NOTICE OF CHANGE

MIL-STD-2088A
NOTICE 1
05 May 1997

DEPARTMENT OF DEFENSE
DESIGN CRITERIA STANDARD

BOMB RACK UNIT (BRU), AIRCRAFT, GENERAL DESIGN CRITERIA FOR
TO ALL HOLDERS OF MIL-STD-2088A

FIGURE 1. 14-inch hook spacing, Type I, bomb rack unit (BRU)
geometric relationships.

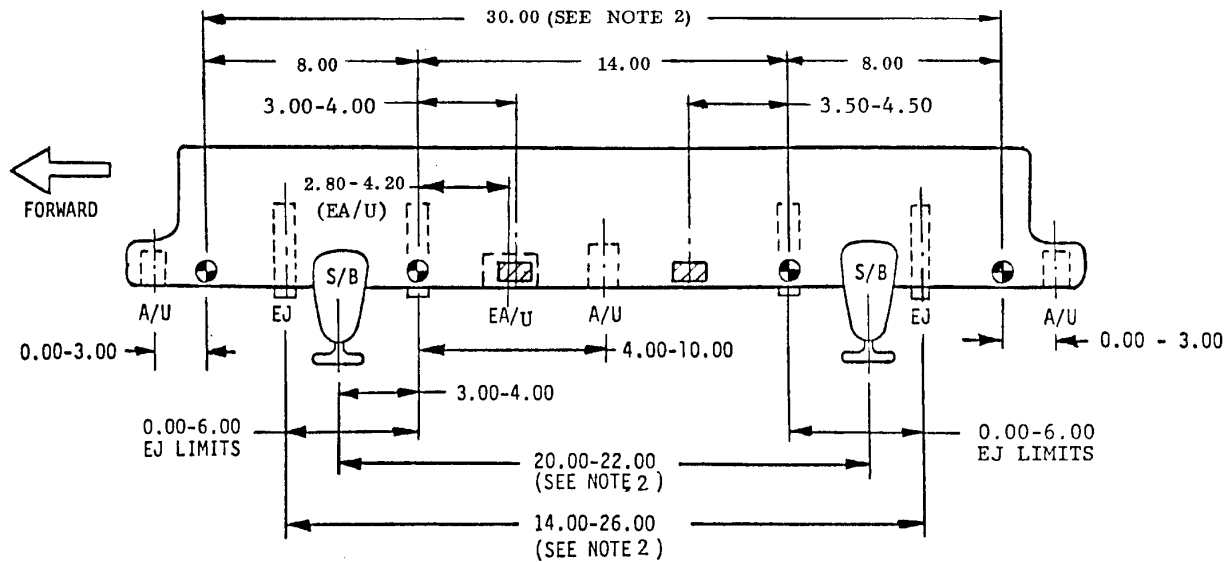
14 and 30-inch suspension. BRU lower surface to store upper surface clearance shall be as specified in MIL-A-8591 (STANAG 3575 Ed.5 and AIR STD 20/10). After a store has been released, the latching system shall engage and latch the next loaded store without additional actions of the loading crew. The vertical latching force required to engage the store shall not exceed 25 pounds per hook for Type I BRUs and 50 pounds per hook for Type II BRUs. The vertical support shall be located as shown in Figure 1 and Figure 2. Ejector feet shall not impact the weld areas as defined in NAVAIR bomb assembly drawings (30003) 923AS101, 2841466 and 1380547.
